**SUBJECT: Subcontract S005242-F for NCSX Modular Coil Winding Forms  
PPPL Non-Conformance Report (NCR) 3684**

Attached *for information* is dispositioned Princeton Plasma Physics Laboratory (PPPL) Non-Conformance Report 3684, dated 30 November 2006 titled NCSX – Modular Coil Winding Forms.

<b>Status</b>	5 - Corrective Action Needed	<b>Trend</b>	01-Deviation From Doc/Proc
<b>Department</b>	NCSX	<b>Division</b>	WBS 141
<b>Source/Org</b>	VENDOR		
<b>Item Dwg/Part#</b>	SE141-114, r8 - MCWF A-4	<b>Procurement #</b>	S005242-F
		<b>Cost Center</b>	9450 1*** 1404
<b>RAP#</b>	3209	<b>Job Doc #</b>	S005242-F
		<b>Vendor</b>	Energy Industries of Ohio
<b>RAP Title</b>	NCSX - Modular Coil Winding Forms

## A4 “gully” by Tee Radius

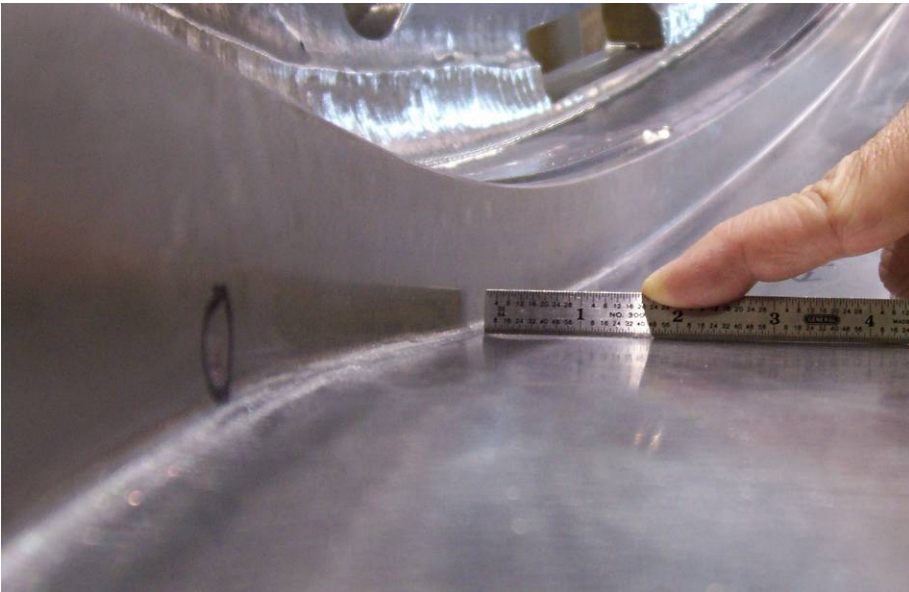
MCWF A-4 shows the following conditions (photos attached) exceeding the tolerances of SE141-114, R8:  
 1) Between Holes #86 to #94 the legs of the Tee (septum) have a step down area that dips, on the long leg, .008" to .028" from the flat portion of the leg. MTM's measurements of the long leg in this area show it .002" to .003" above nominal, so the "gully" ranges from .010", just at the upper limit of the tolerance of .020" profile equally distributed bilaterally (+/- .010"), to as much as .020" below that tolerance. There is a similar, though more shallow, "gully" on the short leg.  
 2) Between Holes #48 & #52 the radius between the long and short legs of the Tee exceeds the specified .11" +/- .01".

This photo shows the location - between Holes #86 to #94 on the side of the casting facing up on the shipping skid.

Note in both photos the shadow along the base of the tee. This is step, readily detected by hand, from the flat of the tee down toward the radius.

The "gully" areas should be filled in with CTD 540 epoxy / glass bead to provide an even surface and support for the winding. This condition will be discussed with EIO/MTM during the next Quality call to avoid this condition with future castings.

## A4 "gully" by Tee Radius

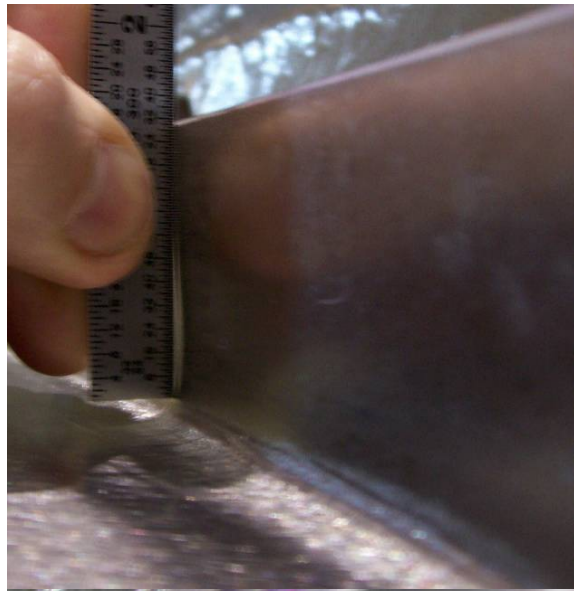
More shots of the straight edge on the long and short legs of the tee.

The first photo shows a 5/32" gauge. The second is the required 1/8" radius gauge

### A4 “gully” by Tee Radius

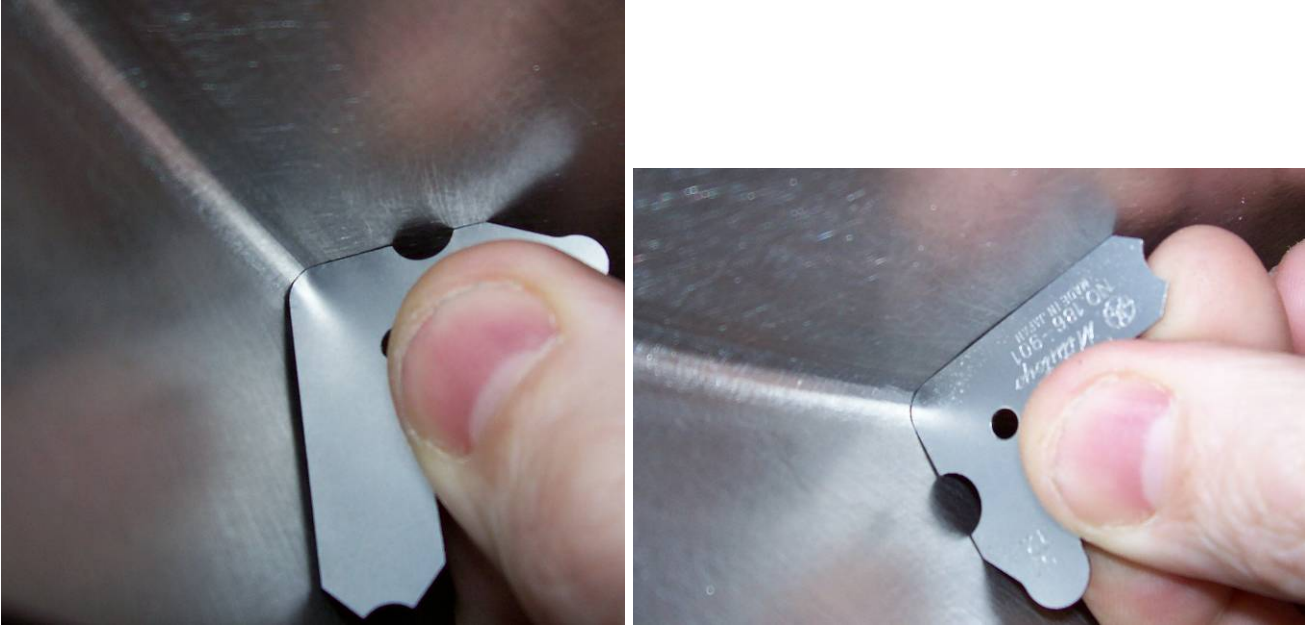
These photos show a short area, between holes #48 & #52 on the bottom side (as-shipped) of the casting, where the radius did not pass the gage check.

The first shows the required 1/8" gage and the second shows the next size bigger 5/32" gage.
